**Subject: Supplemental Geotechnical Review #2  
Potential Impacts from Proposed Development of New Single Family  
Residence at 1923 Mapleleaf Court  
Lake Oswego, Clackamas County, Oregon  
EEI Report No. 18-061-3**

Per your request, **Earth Engineers, Inc. (EEI)** is issuing this report so that you may submit it to be considered by the City of Lake Oswego Development Review Commission (DRC) and City of Lake Oswego engineering staff for LU 17-0065 (a request for a minor partition creating 2 parcels).

RSS issued an undated addendum geotechnical report titled "Addendum for rear lot at Mapleleaf Court" to address the City's concerns (reference Exhibit F-12, received by the City of Lake Oswego on April 20, 2018). The following are our review comments of the addendum geotechnical report submitted by RSS.

**FIGURE 1:** Cross-section (not to scale) of Rutherford residence slope based on EEI's field measurements; RSS did not analyze the steepest portion of the slope

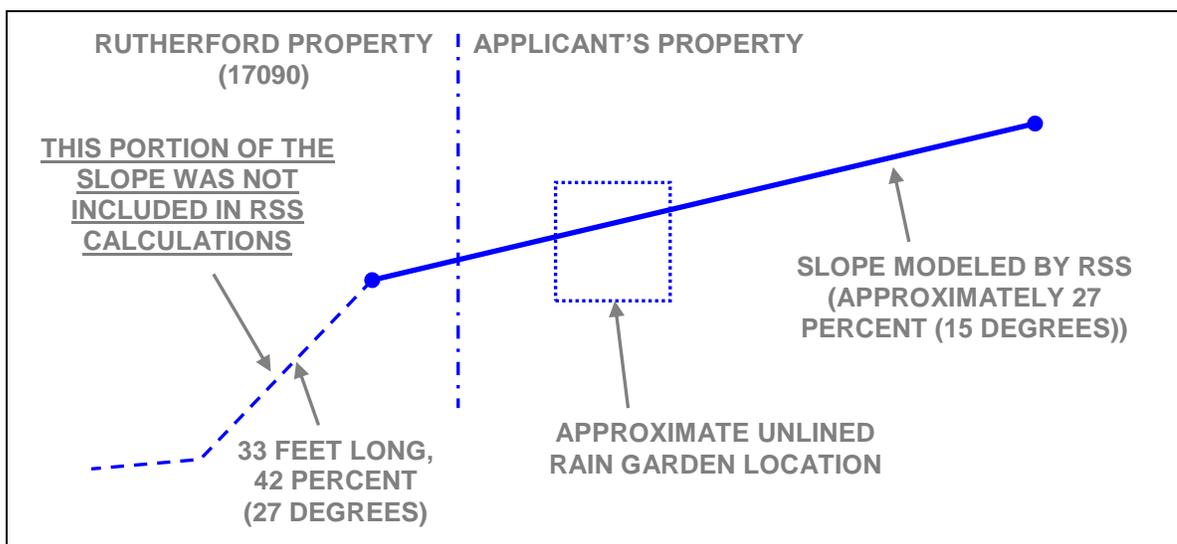
Generally consistent with the standard of practice for geotechnical engineering, RSS has submitted quantitative slope stability calculations using XSTABL computer software in their undated addendum report. Unfortunately, the analysis by RSS was incomplete and presents results that don't reflect the actual slope conditions. They only modeled the upper portion of the slope at the unlined rain garden, which is less steep (averages about 27 percent according to RSS and verified by EEI). They did not include in their model the lower portion of the neighbor's slope that is most critical (i.e. the most steep at about 42 percent as verified by EEI).

EEI Principal Geotechnical Engineer Troy Hull was on site on April 24 and measured the actual slope angle with a hand held angle finder and measuring tape. The results are shown in Figure 1 (which also superimposes the slope modeled by RSS). As is shown, the slope modeled by RSS at the proposed unlined rain garden is much shallower than the actual slope in question. The slope stability calculations that show the slope will be stable, are un-conservative, and do not reflect the actual conditions at the neighbor's property. **We recommend the City not accept the slope stability analysis performed by RSS.**

**FIGURE 2:** Applicant's site plan showing location of unlined rain garden and overflow drywells (base drawing source: RSS revised geotechnical investigation report dated February 12, 2018).

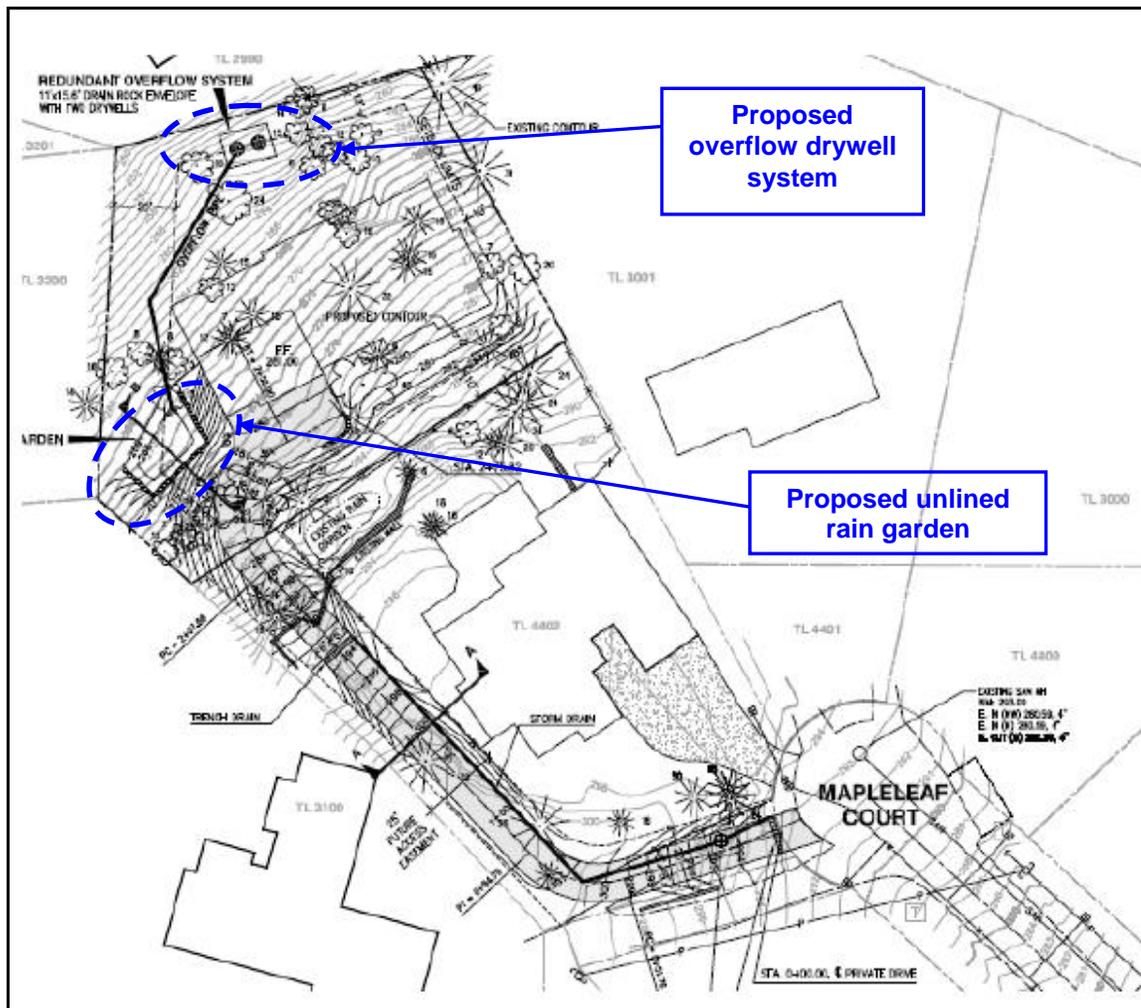
2. **The applicant's geotechnical consultant did not properly model the slope at the proposed overflow drywell location.** The RSS addendum report states that they performed slope stability calculations for the overflow drywell's location. The report also states that their calculations demonstrate that the slope will be stable. However, we reviewed the report and RSS did not perform a slope stability analysis of the slope below the overflow drywell. Figure 2 below is the applicant's drawing that shows where the overflow drywell will be located. Figure 3 below shows that only one cross-section was modeled by RSS and it was at the proposed unlined rain garden. **We recommend the City not accept the RSS addendum report because their conclusion that the slope at the overflow drywell was not supported by actual slope stability calculations.**
